TECHNICAL NOTE

2020s0715
 La Gigoulande Quarry
 Granite Products (C.I) Ltd
 18th September 2020
 Rebecca Varga-Schembri and Oliver Francis
 James Howard and Alastair Dale
 La Gigoulande - Initial assessment of Jersey Water proposal

This document has been prepared as a technical statement to provide Granite Products, the owners of La Gigoulande Quarry, with information to support discussions and representations regarding the practicality of Jersey Water's proposal to use La Gigoulande as a water storage reservoir. The approach is to consider the technical implications of Jersey Water's proposals to understand whether the principle of such development can reasonably be supported. Initially the focus of the assessment is to understand the available storage volumes and the technical challenges and practicalities associated with a number of different approaches to store water within the existing void in the western portion of La Gigoulande.

Figure 3-1: Cross section illustrating groundwater fluctuations

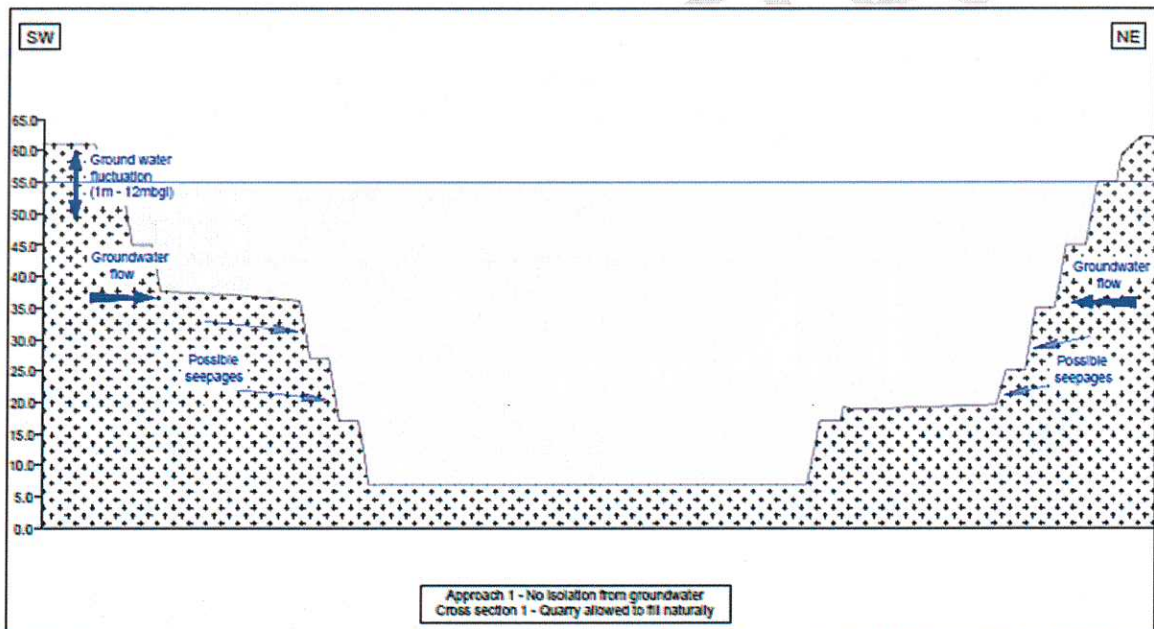
This approach has potential to allow for extraction of stored water at a high rate subject to sufficient recharge. A significant limitation in this approach however relates to the connection between the ground water and the water within the quarry. This connectivity limits the storage volume since excess head above the natural ground water will likely induce seepage losses from the quarry. **Error! Reference source not found.** and **Error! Reference source not found.** illustrate how the quarry would fill naturally and the situations where water would be lost to seepage.

Natural groundwater levels at the site are recorded to fluctuate between 1m and 12m below ground level. From this it is reasonable to infer that water levels within the quarry will likely react in a similar manner although there may be a lag in the response.

Based on the excavation profile at the date of survey (Feb 2019), the volume of available storage would vary between approximately 100,000m³ and 225,000m³ depending on groundwater levels. This approach cannot therefore realistically be expected to provide a reliable or predictable stored volume. Whilst this approach might support use of the quarry as a large water extraction facility, this option offers little benefit over borehole abstractions.

Figure 3-3: Cross section illustrating fractures sealed by grout for Approach 2a

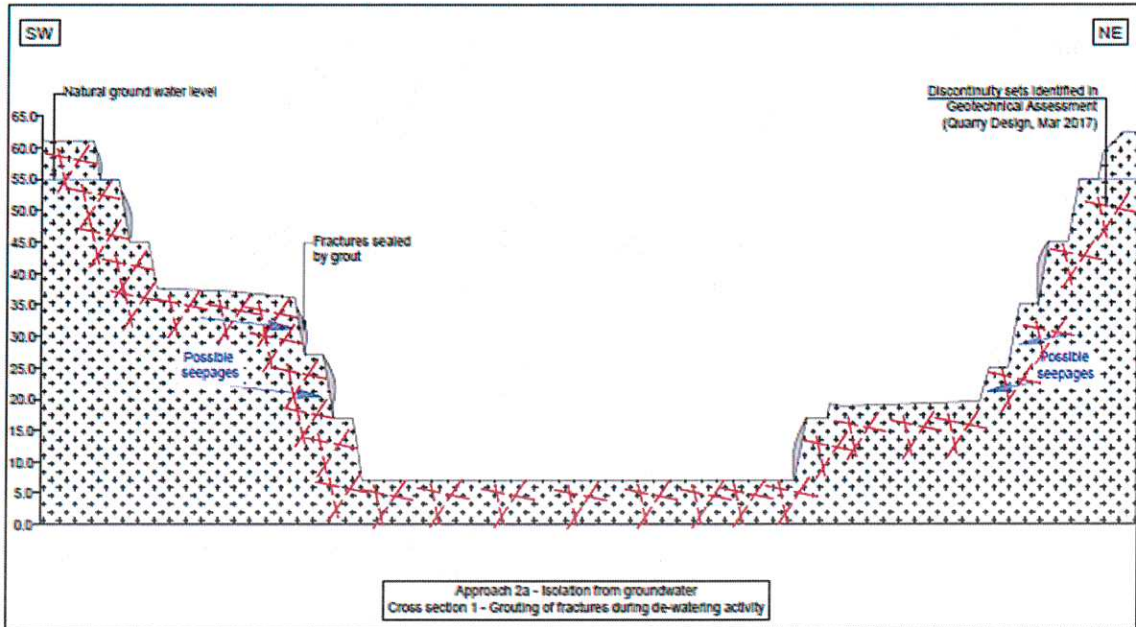
This solution entails sealing fractures by grouting the rock mass around the quarry. This would reduce flux of water into or out of the reservoir. This method has been utilized in underground mines and tunnels and beneath dams to minimize ground water infiltration. It is important to note that this solution can only be expected to reduce, not prevent, seepage to and from the reservoir (**Error! Reference source not found.** and **Error! Reference source not found.**).

Grouting the rock mass around the quarry would involve treatment of a large volume of rock but, given the competent rock mass, it is anticipated that only fractures would require treatment. Validation and subsequent testing would be essential. The most straightforward testing method would involve temporarily ceasing dewatering activity at the active quarry and observing seepage into the reservoir prior to impoundment. This approach would identify defective areas which could then be treated further. It is understood that ceasing dewatering activity for the duration of the test might be impractical due to the need to support ongoing quarrying works elsewhere on site. However, disregarding such testing would leave a significant risk of high seepage loss which will be challenging to identify and treat once the reservoir is filled with water.

Figure 3-5: Cross section illustrating rock self-weight resisting uplift for Approach 2a

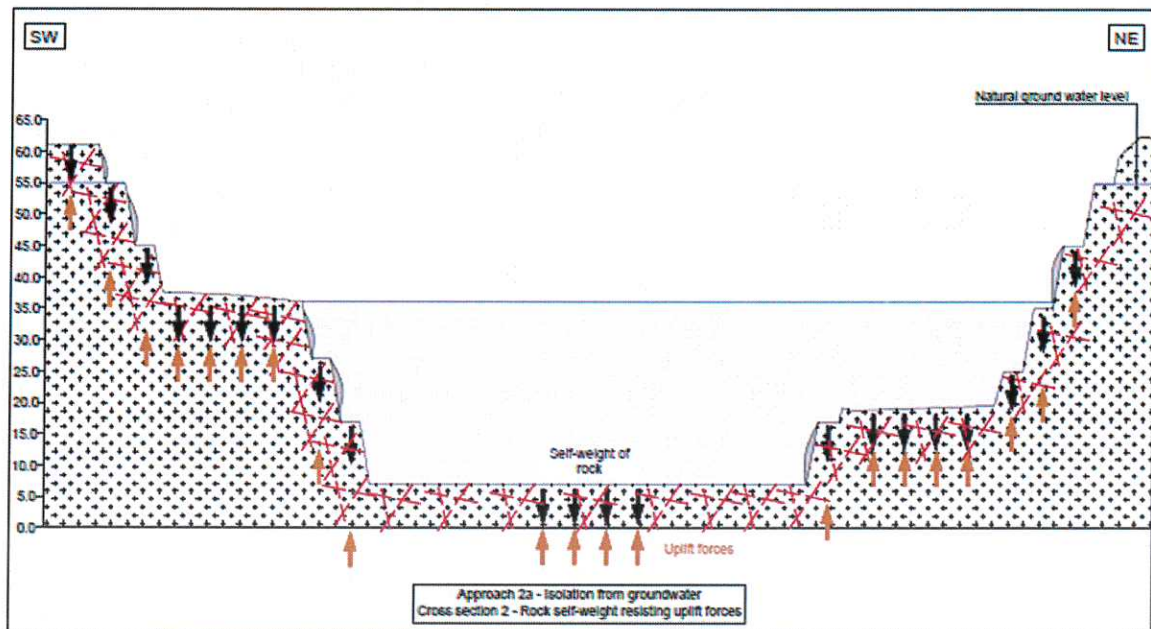
This solution offers advantages in managing uplift pressures because it utilizes the self-weight of the rock to resist uplift (**Error! Reference source not found.**). It does not require maintenance once works are completed and verified by testing. Additionally, this solution would not in itself reduce available storage volume within the quarry. The maximum capacity would remain in the order of 240,000m³ based on excavation profiles at the time of survey (Feb 2019).

Figure 3-6: Cross section illustrating installation of an impermeable structural liner and the volume taken up by the installation for Approach 2b

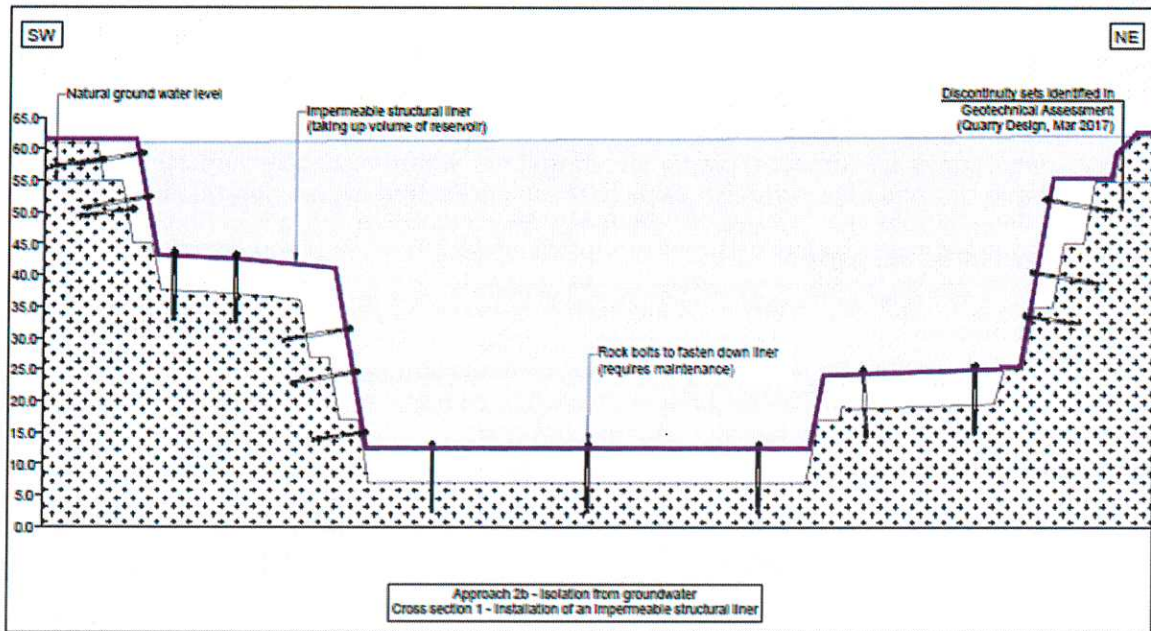
This solution offers a verifiable method of isolation of the reservoir from the water table. However, due to the size of the quarry and the shallow ground water complete isolation from the water table will likely require the liner to withstand significant uplift pressures, potentially in excess of 500kPa. Consequently, it is expected that the liner installation will need to be a sizeable structure, which will appreciably reduce available water storage capacity (**Error! Reference source not found.** and **Error! Reference source not found.**). Preliminary estimates are that the average thickness of the concrete liner would be in the order of 1m. The thickness of the liner and the potential need for adjustments to the profile and geometry of the void would be expected to result in a 10-15% reduction in stored volume compared with Approach 2a

Figure 3-7: Cross section illustrating the requirement of the liner to resist uplift forces for Approach 2b

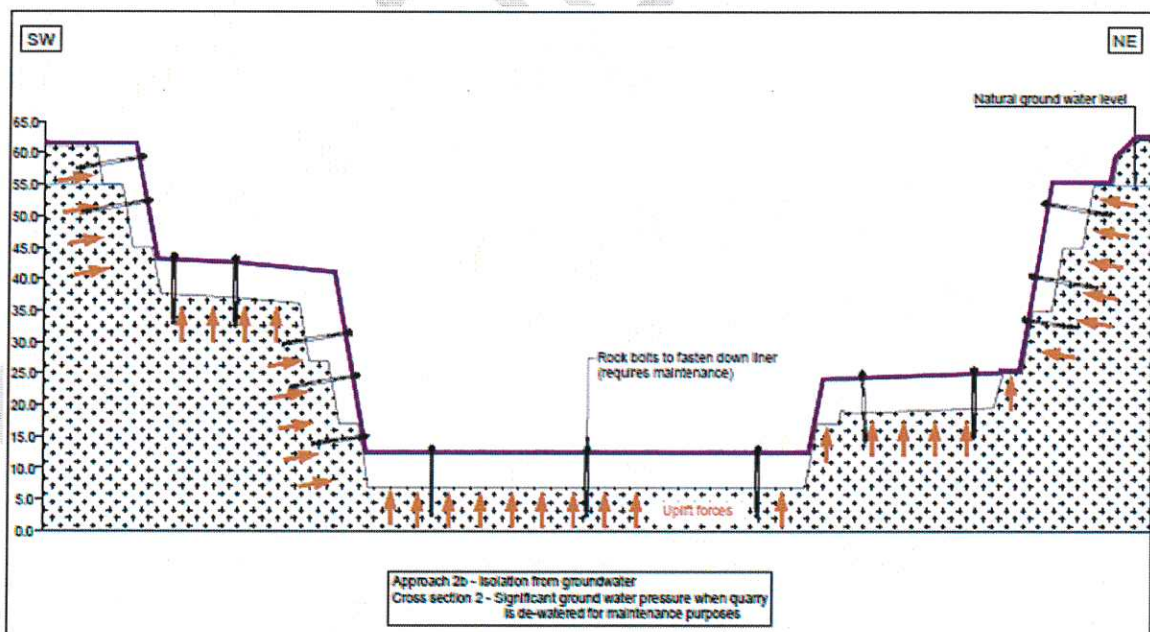
A perpetual commitment to dewatering outside and in the vicinity of the reservoir may be required to manage the external uplift pressures. Dewatering can be expected to be required whenever the water level within the reservoir is low. The requirement for a dewatering system would increase the cost and complexity of reservoir operations and if dewatering failed while the reservoir was empty could result in failure of the structure.
